**CITY OF POMPANO BEACH
DRC COMMENT RESPONSES**

CASE NUMBER: PZ23-12000046

Address: 31 NE 22nd Avenue, Pompano Beach, FL

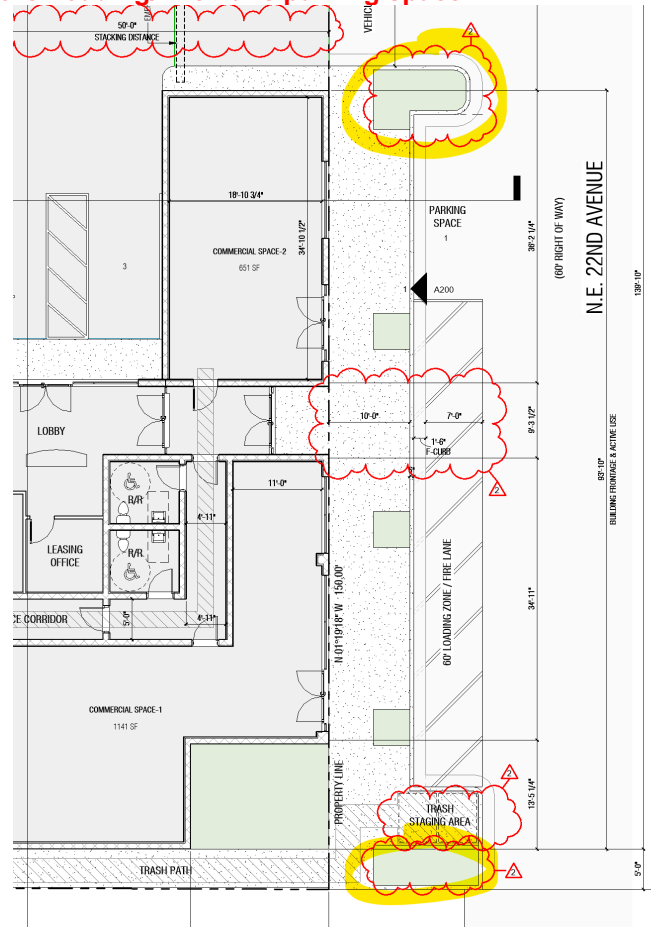
2. Previous comment remains, and additional clarification is provided. Previous comment: The site plan depicts an on-street parking space at the north end of the project site. A 5-foot-wide parking island is required at both ends of the parking space as well as at the south end of the on-street space labeled "LOADING". NEW: The 50-foot wide parking islands that are required at both ends of the on-street parking must be landscaped, not paved as shown on the plans.

ARCHITECT RESPONSE: Refer to Sheet A100 where we have incorporated the 5-foot parking band to the south of the Loading/Fire Lane parking space.

3 SOUTH ELEVATION
SCALE: 3/32" = 1'-0"

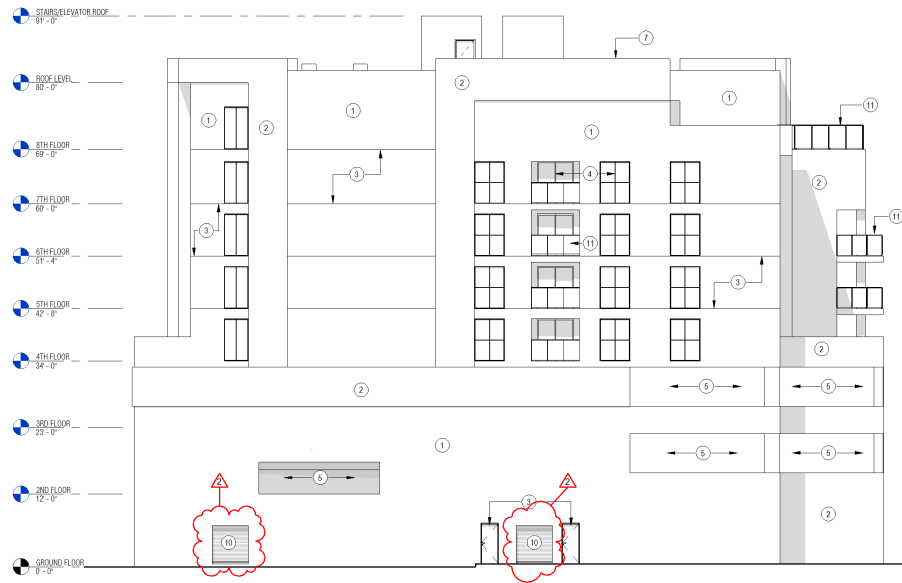
3. The response from previous comment #10 needs clarification. Previous comment: Identify the horizontally-hatched element shown next to the stairwell door on the north building elevation. NEW: The response states "It is an overhead door for trash containers please refer to sheet A-201." However, the north elevation does not have an overhead door, nor does the floorplan show a trash room at the north side of the building. Clarify whether the response is referring to the south elevation.

ARCHITECT RESPONSE: Clarification: Our first submission to DRC, Sheet A-200 & A-201 had an error and had our North and South Elevations labeled backwards. Please reference the latest submission where we are showing the South Elevation that contains 2 overhead doors now, one for the trash room and the other for the storage room. The South Elevation is where you will find the hatch element which represents overhead doors. Please refer to sheet A200 with added keynote #10 which calls for overhead door.

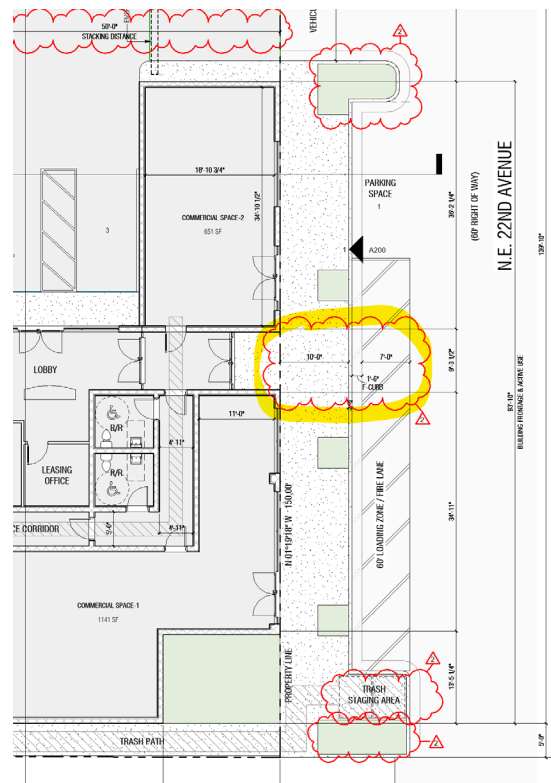
4. Previous comment remains: Verify that the proposed improvements within the NE 22 Ave right-of-way are compatible with the existing conditions. NEW: The proposed right-of-way improvements are to be constructed in conformance with the applicable EOD Street Cross-Section. Establish communication with the City Engineer regarding the preferred improvements in light of the applicable cross-section for the right-of-way abutting the project site.

CIVIL RESPONSE: The proposed ROW improvement are being construction EOD Street Cross-Section type T-4. We are confirming with city engineer for approval. Please refer to Sheets C101 and A100.

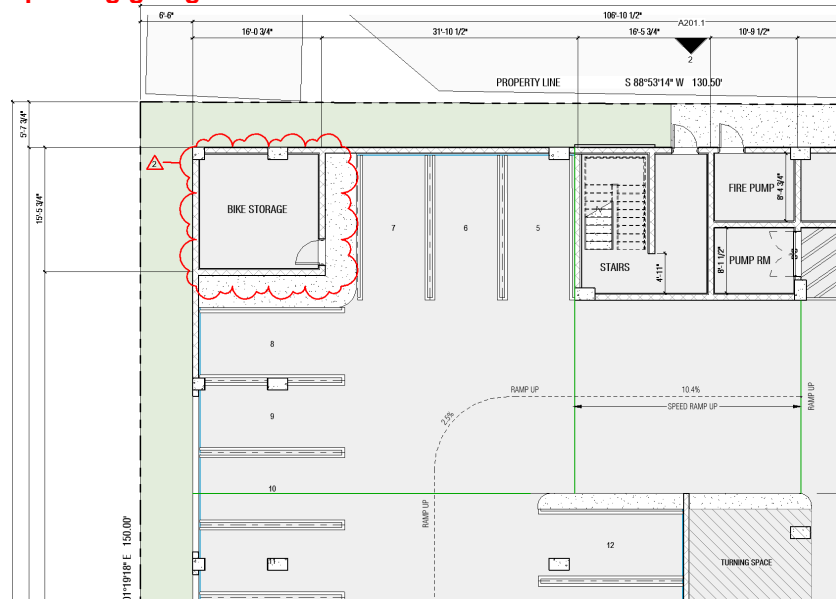
5. Previous comment remains: The Project Data table indicates racks for 20 bicycles is provided. Indicate the location of the proposed bicycle racks on the site plan. NEW: The response states that a bike storage room has been added to the ground floor plan on sheet A-100. However, a room labeled as bike storage was not found on that sheet. Label all rooms on the site plan and ground floor plan with the proposed use, i.e. Bike Storage, Electric Room, etc.

ARCHITECT RESPONSE: Bike Storage Room has been added on Ground Floor on the North West corner inside the parking garage.

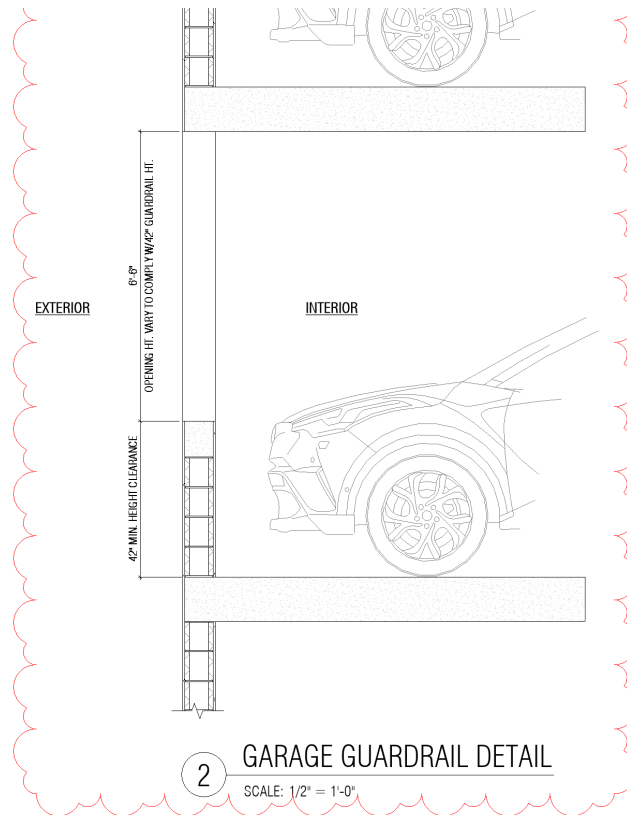
Previous comment partially addressed: The metal louver detail depicts the louvers angled so that the rain will enter the garage. If reversed to alleviate the issue, a second layer of screening will be required.

NEW: Ventilated Metal Painted Louvers remains on the Elevation Key Notes on the elevation sheets.

ARCHITECT RESPONSE: Garage has undergone redesign and louvers have been completely removed from the garage openings, please refer to Sheet A200 for new detail #2.

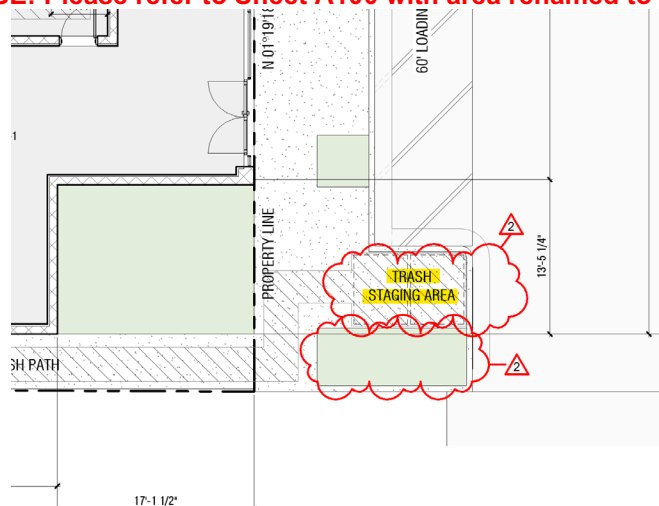
2. Make sure the site plan and the ground floor plan both show the poured concrete pad for the staging area. Currently, only the ground floor plan shows it.

CIVIL RESPONSE: The poured concrete pad has been added.
